Ellie Thornhill
Kirklees Metropolitan Borough Council
Development Management
01st August 2024
Your Ref: 2023/92490

An objection to the development at Dowker Street (planning application 2203/92490) was received by AJP on the 27th June 2024 by the Environment Agency (EA). Below is the objection that this letter is commenting on (found in italics). Our answer is in normal type.

PROJECT: DOWKER STREET MILNESBRIDGE HUDDERSFIELD

Figure 1: Extract of the drainage strategy

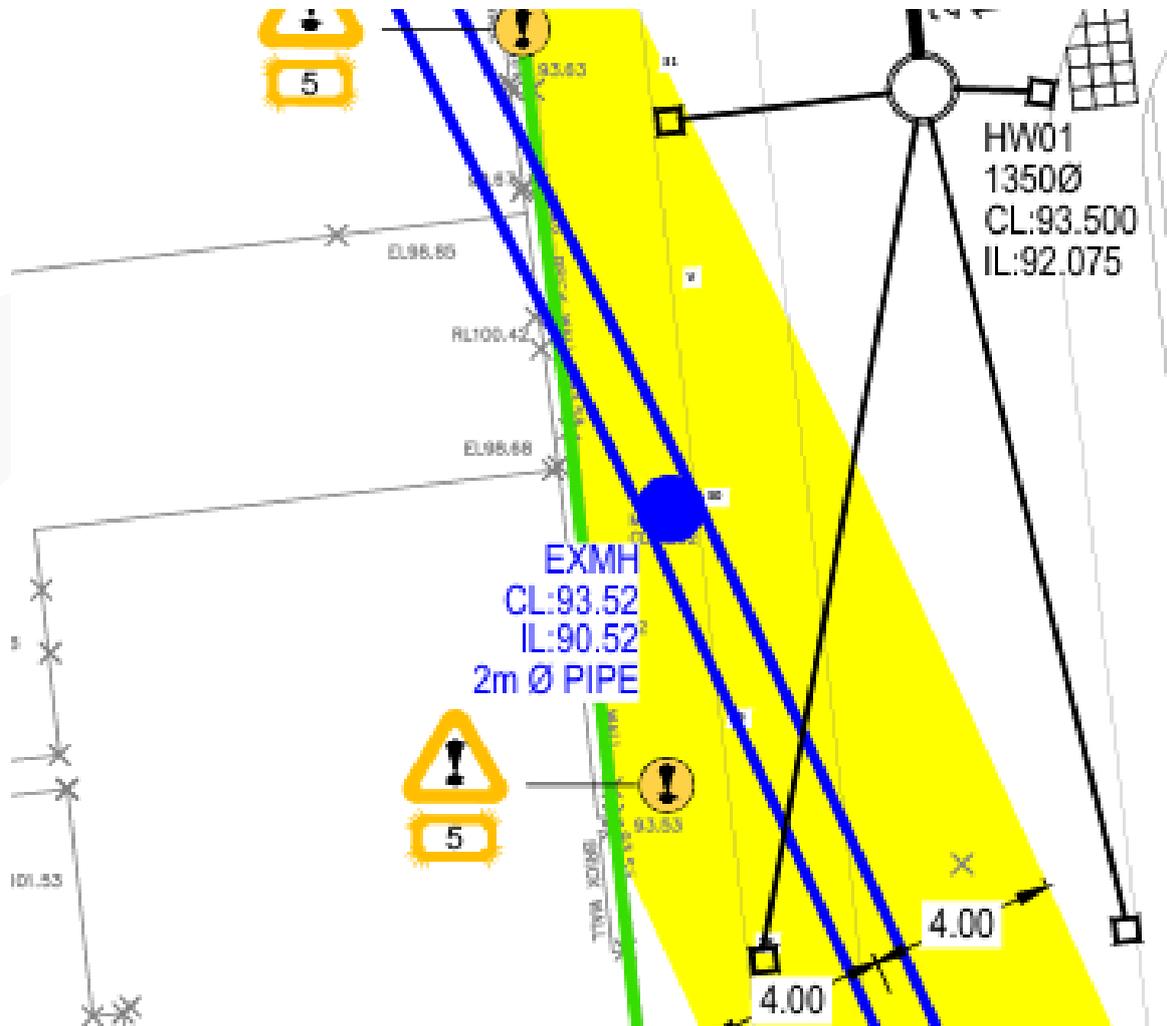
We note the applicant has included information regarding modeling the blockage scenario using the 1 in 100-year event plus climate change model and included a 50% blockage of the total surface area at Node 10. The FRA needs to assess the potential worst-case scenario. As such we expect a 100% blockage scenario to be assessed, not a 50%. If the applicant plans on keeping the 50%, we need justification as to why.

It is believed that 50% blockage is acceptable because it is proposed that the culvert will be reinforced, this reduces the likelihood of collapse within the culvert, from the existing situation. Furthermore, this culvert is approximately 2m in diameter, a total blockage is extremely unlikely because the cover above the culvert is less than 1m. Therefore, a total collapse would only fill the culvert up to 50%. A 50% blockage would also be assuming that the smaller particles would not be washed downstream into the river. Please see below an extract of the drainage survey indicating the size of the culvert.

Blockage is very unlikely due to maintenance, because the culvert is over 12m² in area and has a slope of more than 1 in 100.

‘Sewer for Adoption’ recommends that a surface water sewer should have a gradient of more than 1 in 100, to enable self-cleansing. Therefore, this culvert is very unlikely to be blocked by sediment.

TITLE: DRAINAGE LAYOUT

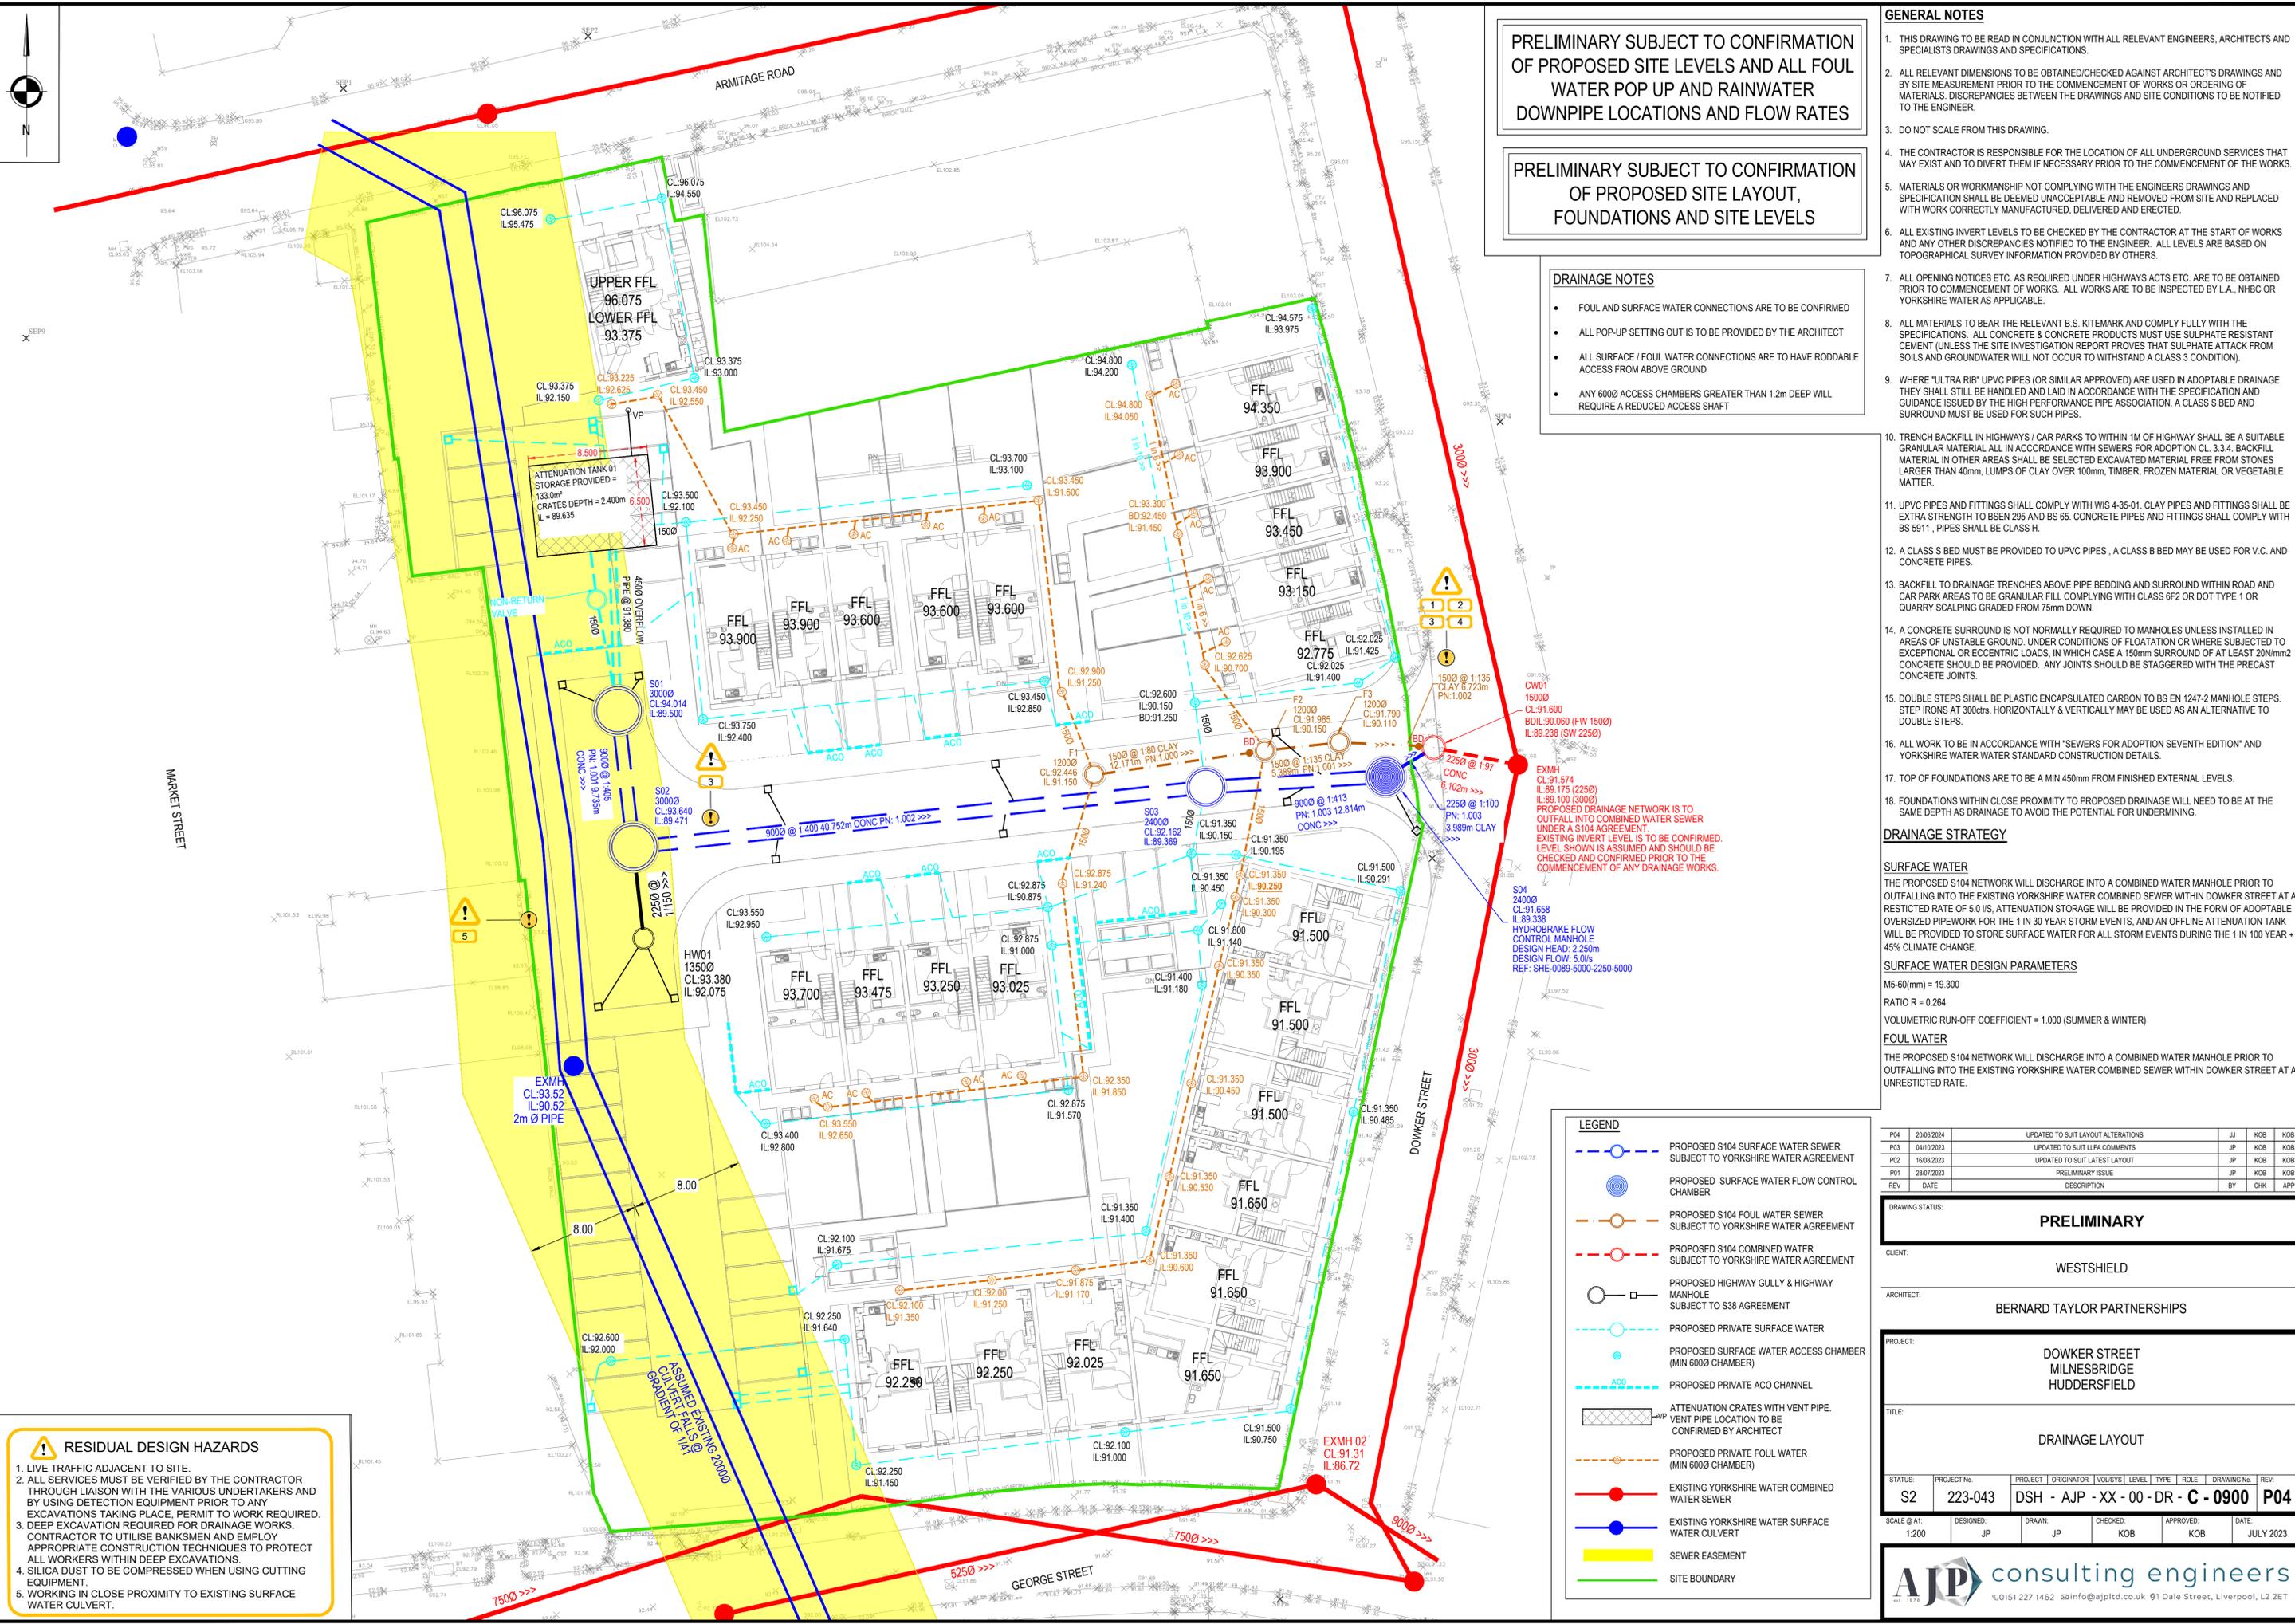
The submitted documents present finished floor levels relative to ground levels. Finished floor levels need to be presented in metres above Ordnance Datum (mAOD) so that this can be compared to the design flood level to show that the development is set a suitable height above the flood level.

Please note all the finished floor levels are to mAOD. Please review in Appendix A the resubmitted drawing, indicating the floor levels.

Drawing Title
 GEOPHYSICAL RESULTS:
 GPR INTERPRETATION

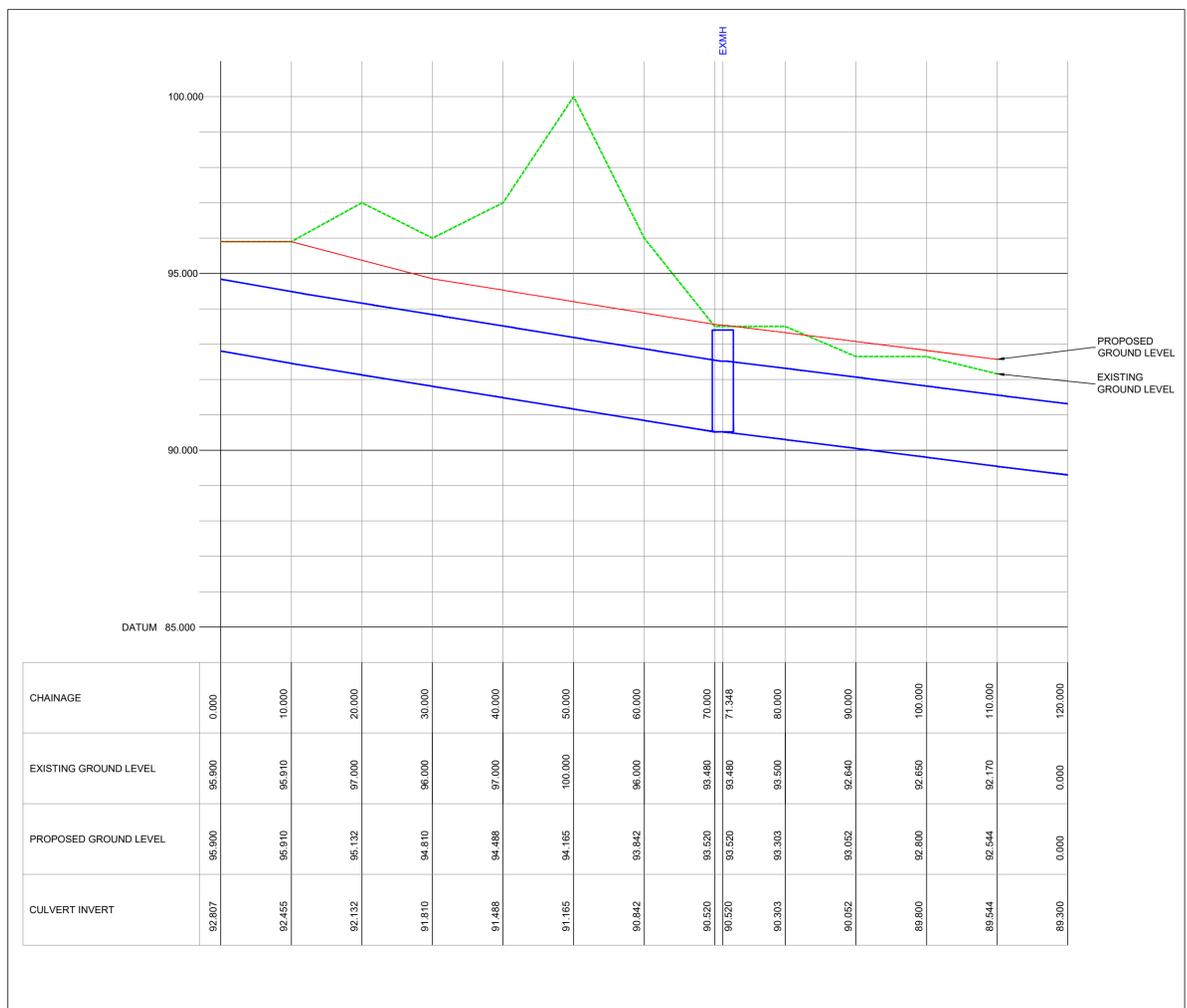
Our concern is not how to get to the location of the culvert from a vehicular access point of view, but once the proposed development is in place, will this make it harder to access the culvert itself, ie will the concrete slab get in the way of accessing the culvert for repairs or will any existing access points such as manholes be affected? The applicant must demonstrate in their revised FRA that maintenance access will not be compromised. Please note that we have assumed if maintenance is needed, machinery and vehicles or maintenance personnel can already access to the location of the culvert. Therefore, we need clarification on the above.

As per the drainage survey there are already access points to the watercourse, these are already reinforced. Please see attached survey drawing indicating said manhole within the site boundary.

As indicated in Appendix B, the manhole is made of reinforced concrete and is unlikely to require more enforcement.

It is the intention of the proposed development to only reinforce the culvert itself and not the manhole, as the manholes are reinforced. Therefore, access will still be there once the sewer is built.
